**Public Hearing for Planned Unit Development  
(PUD) Amendment - Lot 1, Southport West Replat  
Five - HOA Restaurant Holder, LLC**

**RECOMMENDATION REPORT**

CASE NUMBER: PPUD-18-0005

RE: Hooters Restaurant  
Proposed Planned Unit Development (PUD) Site Plan Amendment - Initial  
Review

**EMERGENCY VEHICLE ACCESS PLAN**

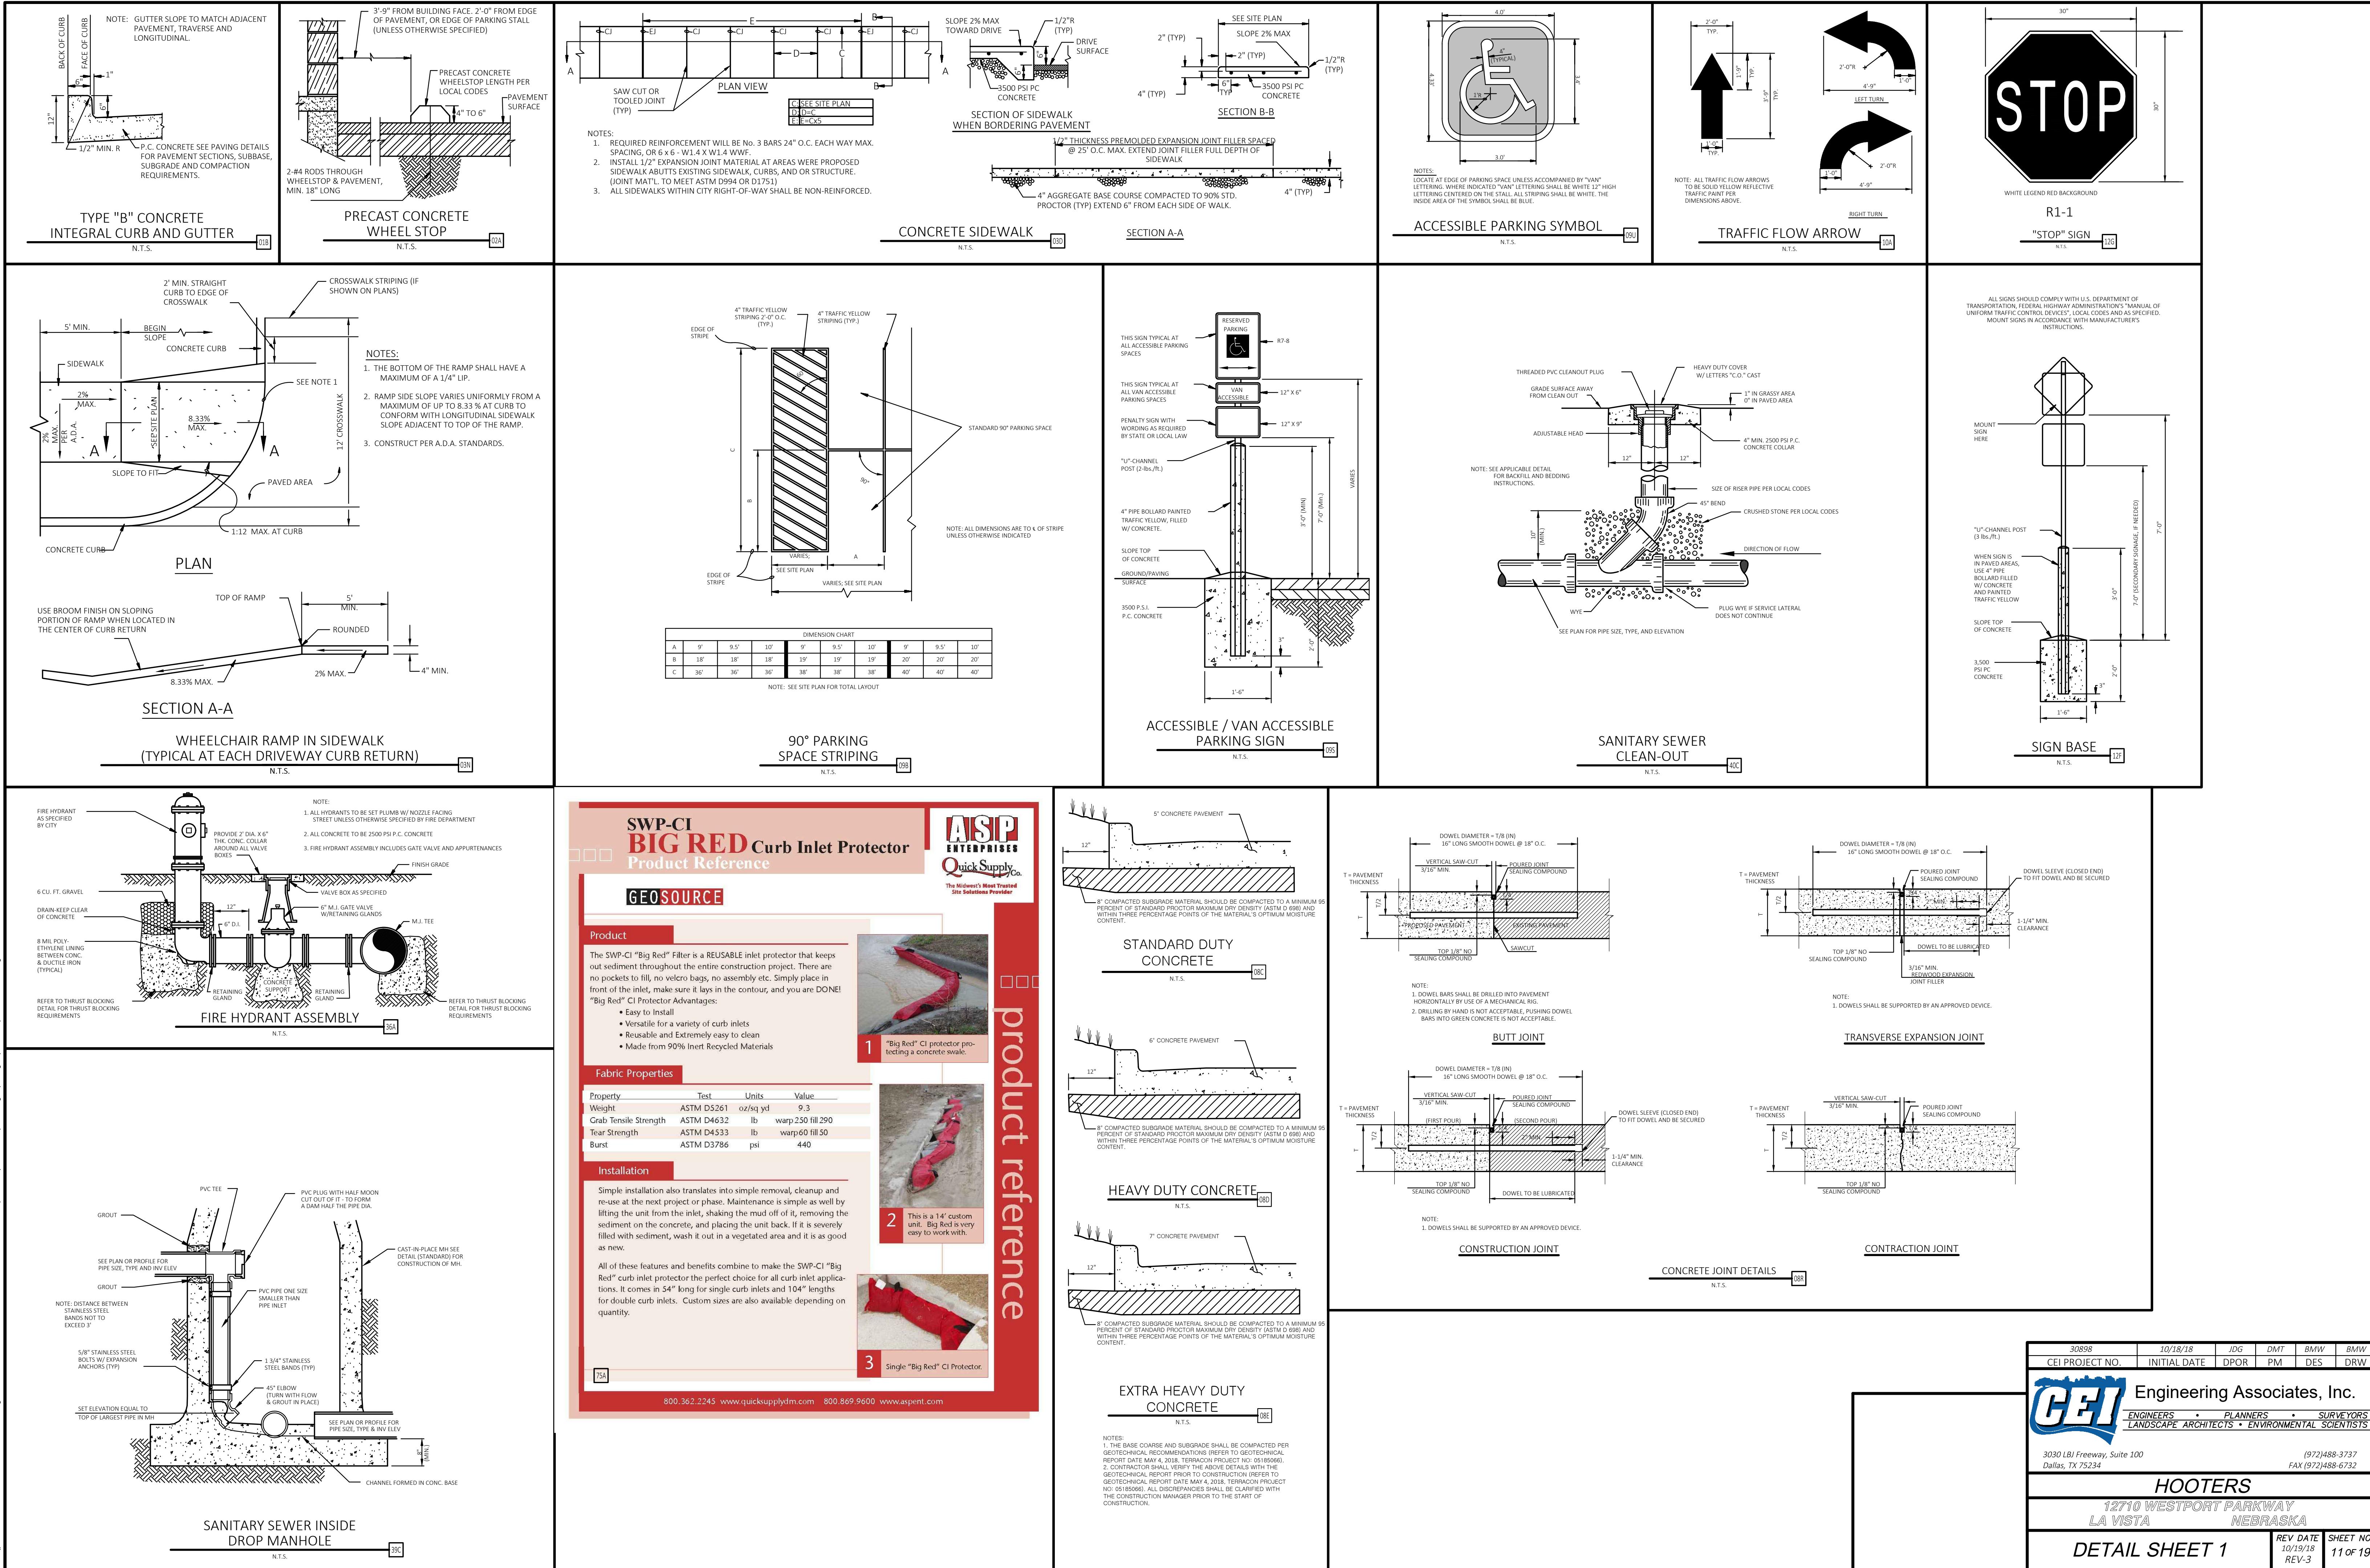
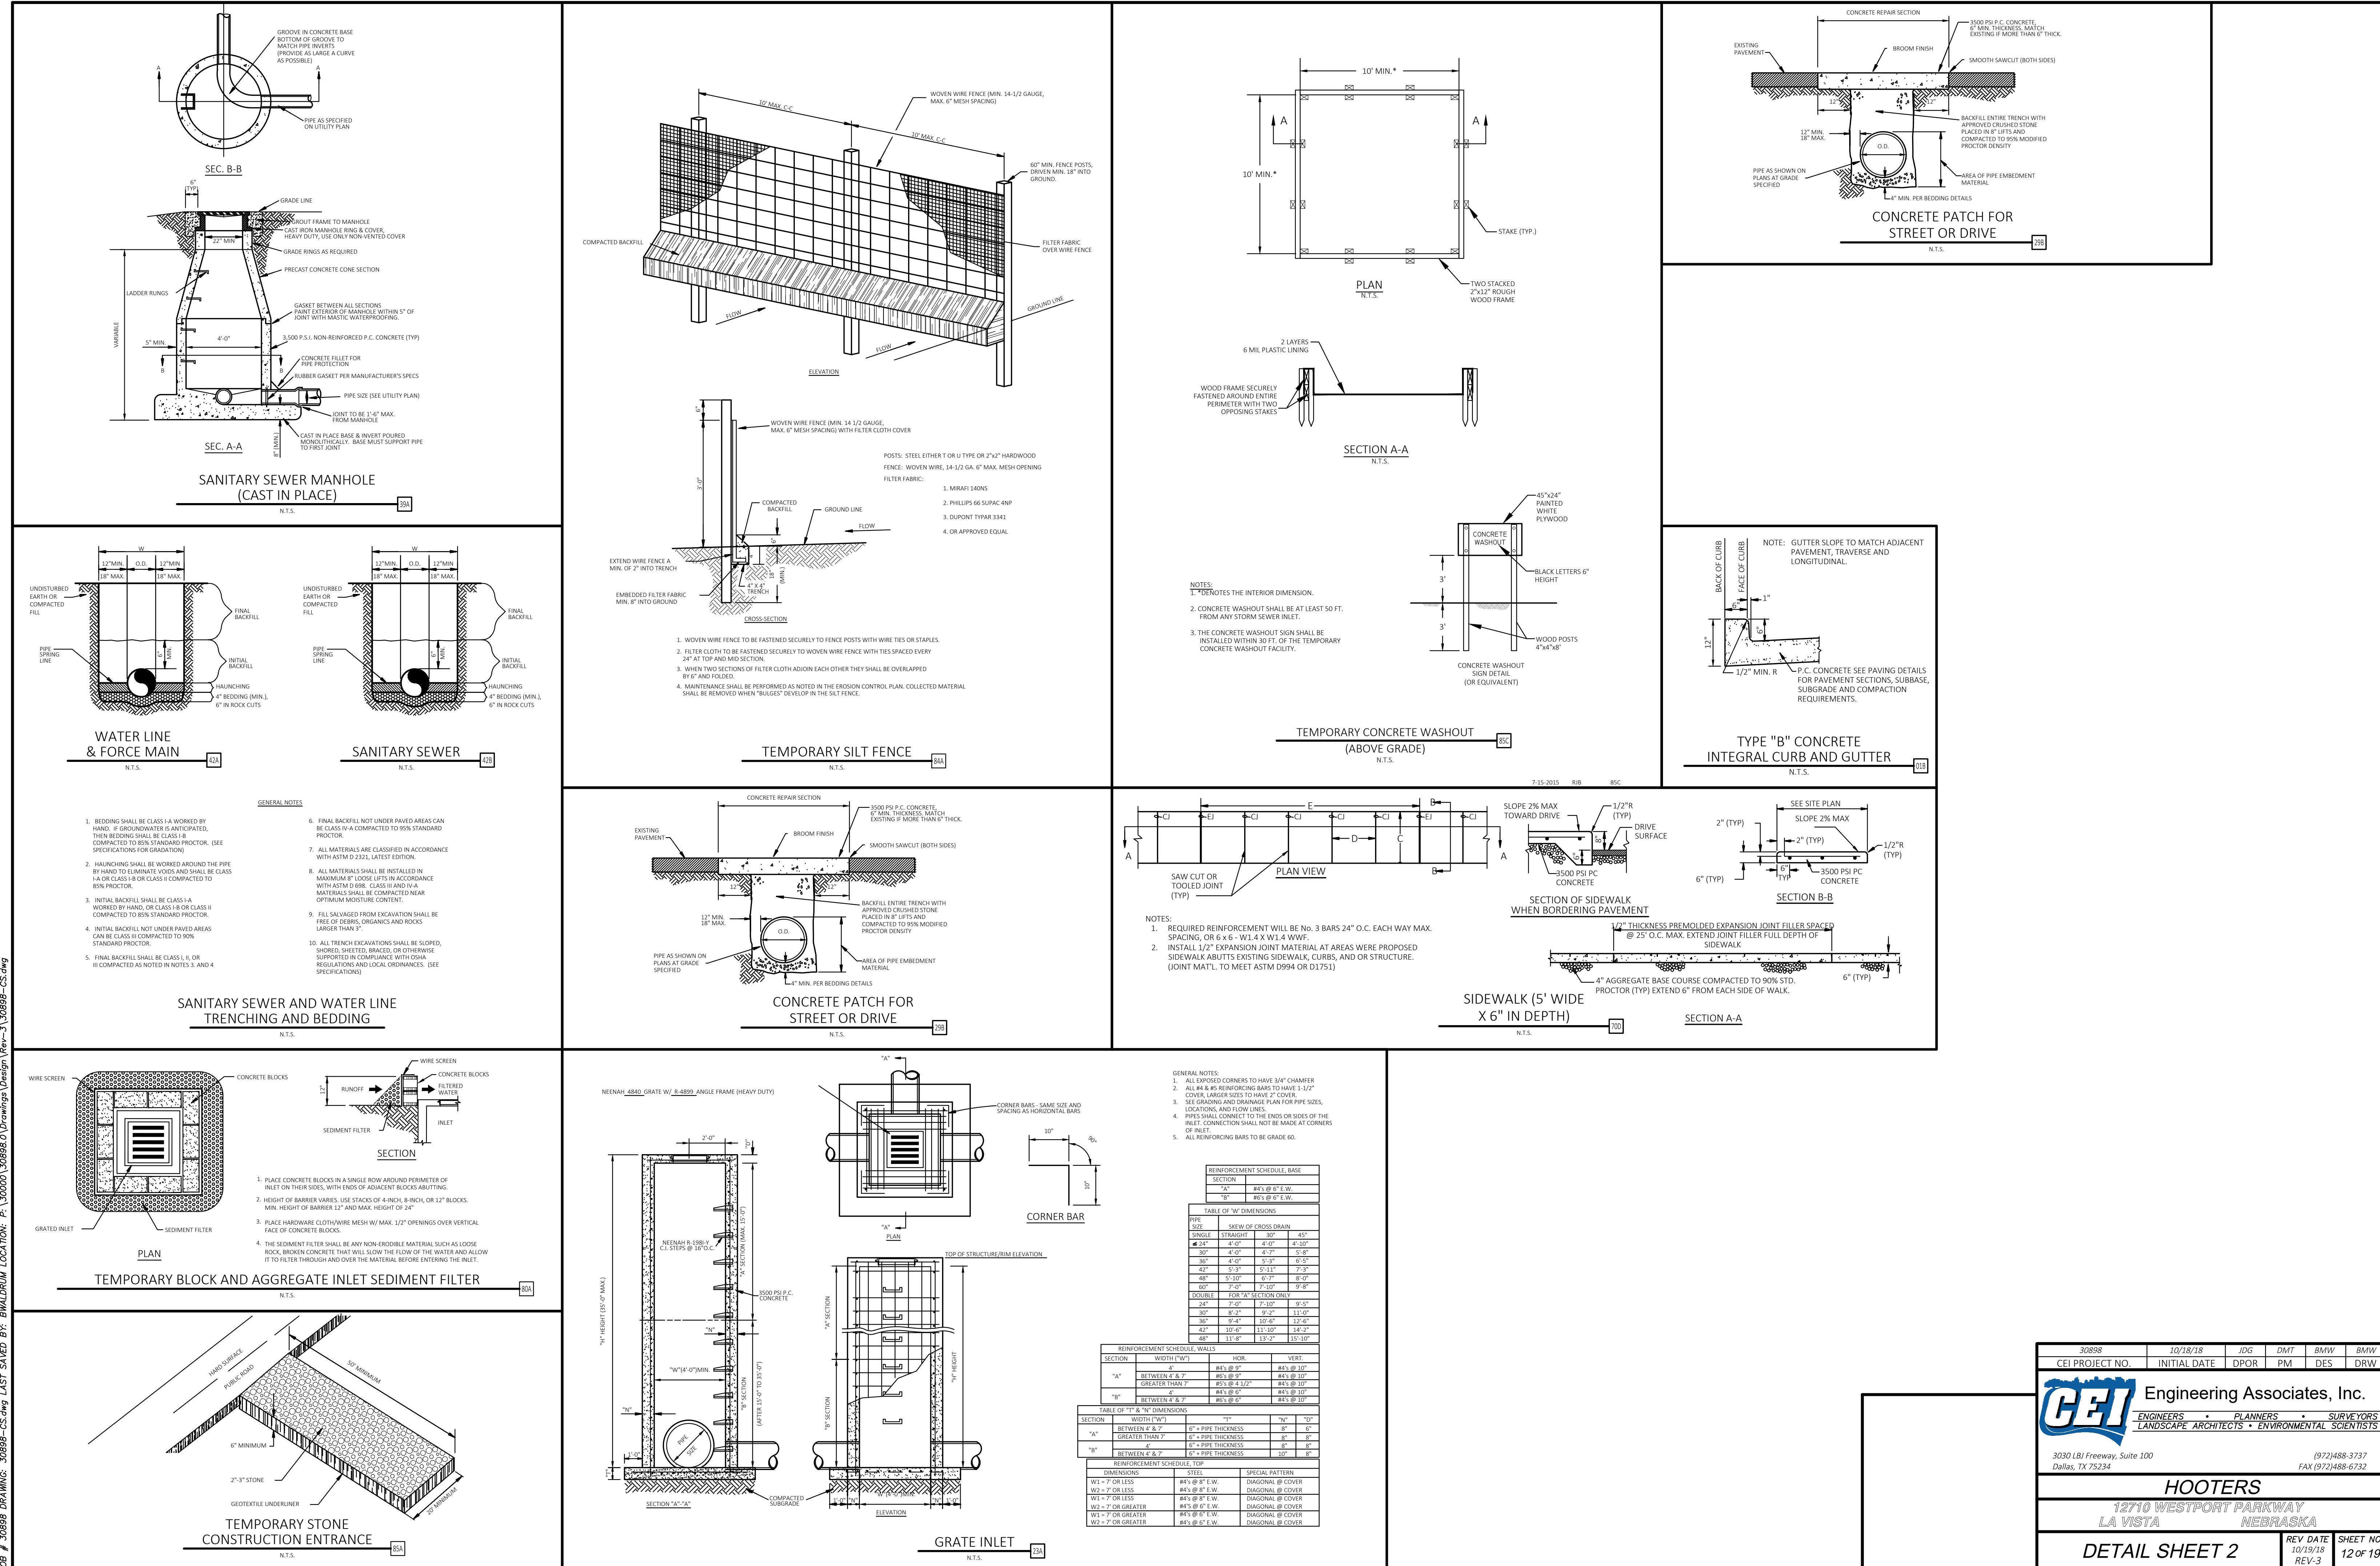
4. Article 5.15.04.04: The Papillion Fire Marshall's office requires the provision of a separate Emergency Vehicle Access Plan which includes Site Plan, Fire Lane, Fire Hydrants, PIV, and FDC - Use Auto-Turn Professional, or similar program, using specifications provided by Fire Marshal.

**The revised plans include an Emergency Vehicle Access Plan sheet.**
